PROJECT  
Woodford Co. HS Emergency Structural Rep  
RTA 2133

VISIT NAME  
220614 FIELD OBSERVATION REPORT

REPORT NO  
002

ITEM: 002-001

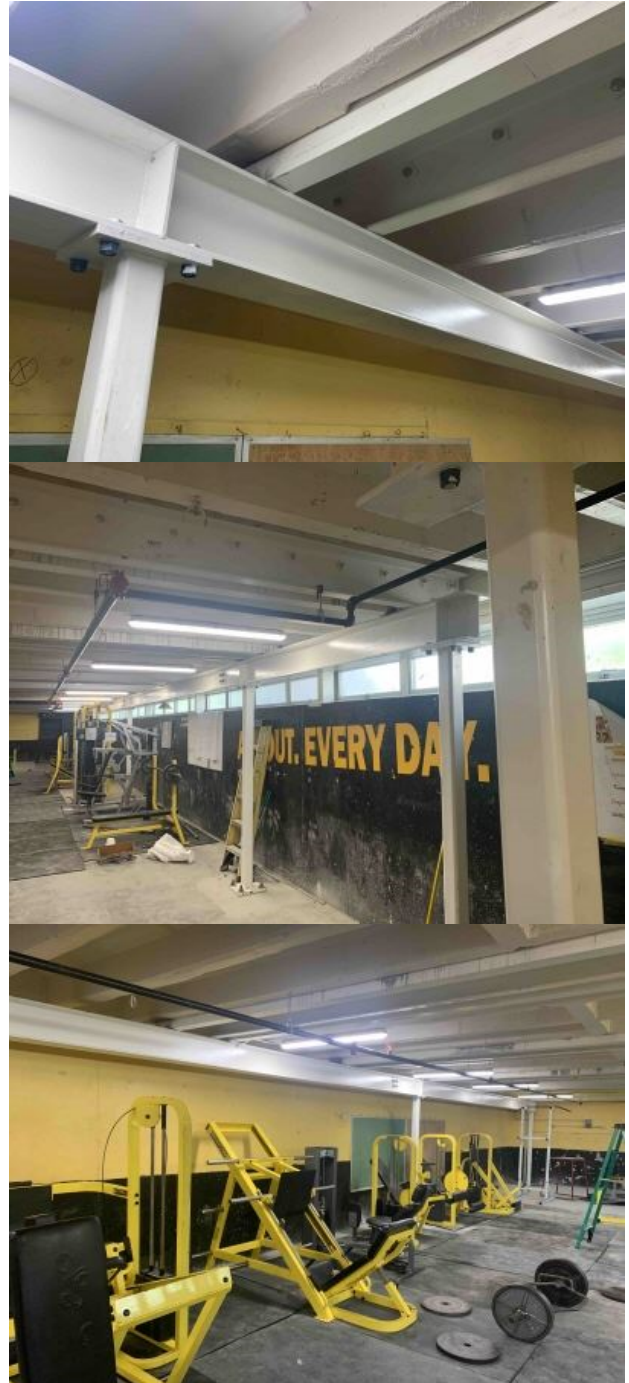
REMARKS: Concrete splatter needs to be cleaned from exterior wall and windows.

ITEM: 002-005

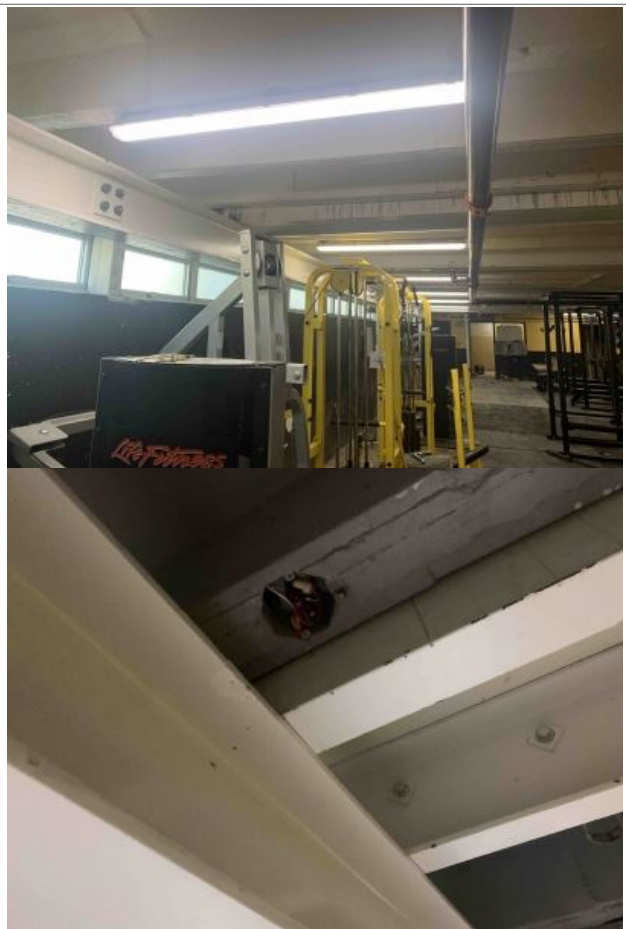
REMARKS: Lighting installation is near completion.  
Missing fixtures in both storage rooms.

ITEM: 002-009

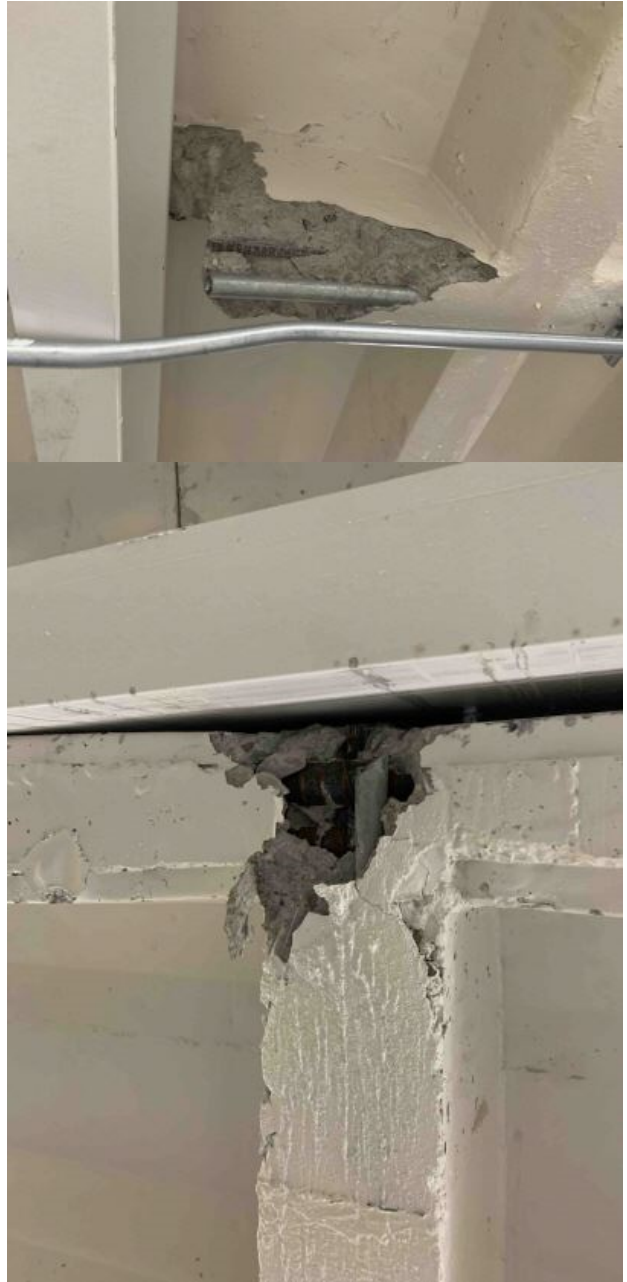
REMARKS: Cut abandoned conduit flush with wall.  
Fill with grout so it is smooth.

ITEM: 002-012

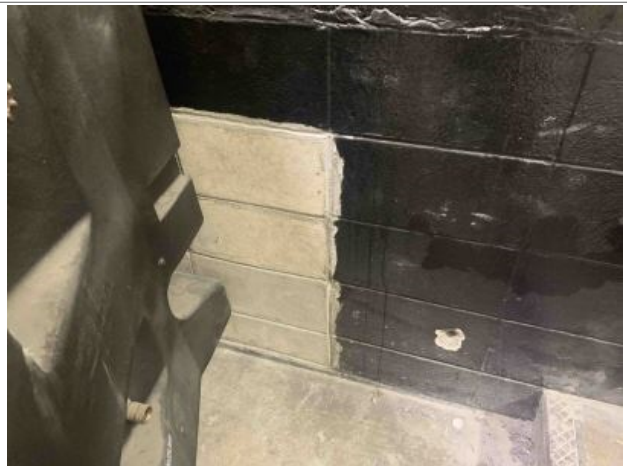
REMARKS: Concrete placed in holes from the upper levels. Finish is acceptable. This level and the bleachers need to be cleaned free of cement and dust.

ITEM: 002-014

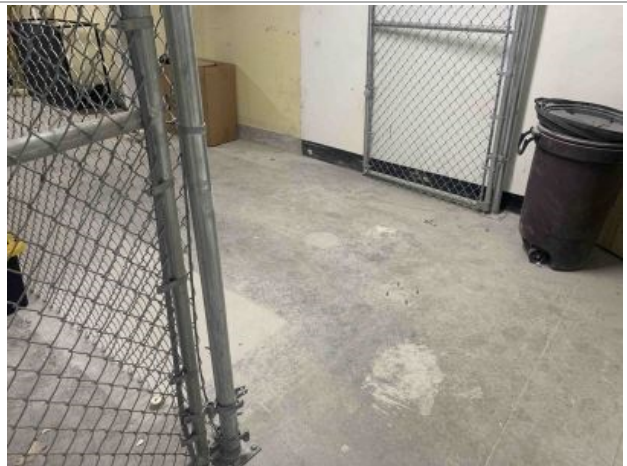
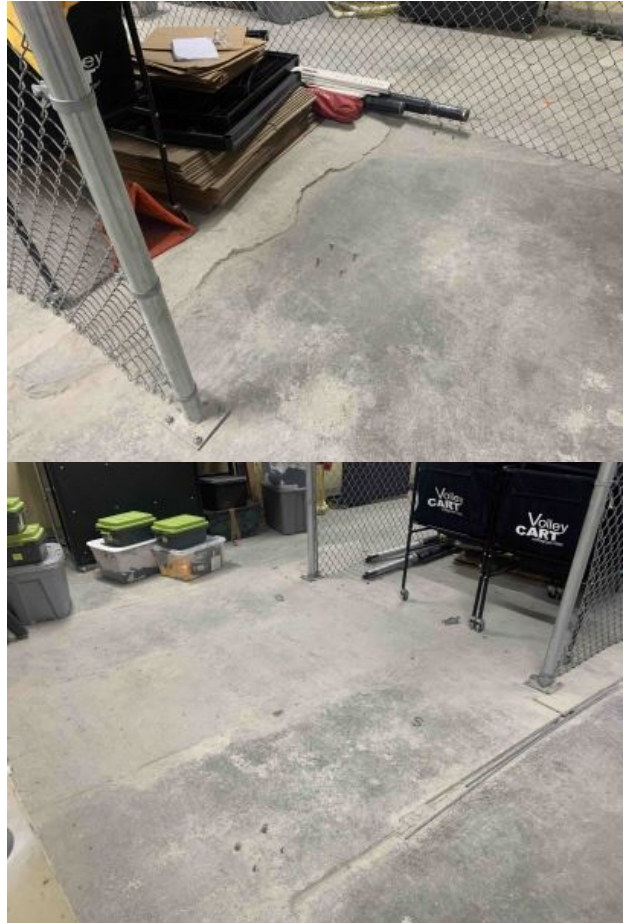
REMARKS: Additional chain link fencing to be installed back to its original conditions. Please consult with Kody Reed, the custodian, or the architect as required.

ITEM: 002-015

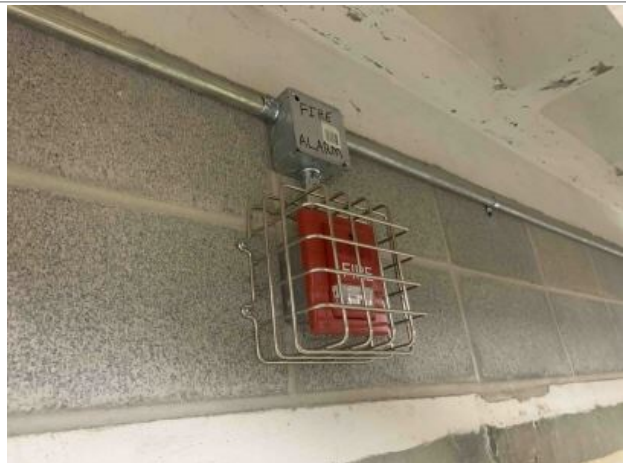
REMARKS: Fire alarm installation is near completion.  
Final installation is planned for tomorrow.
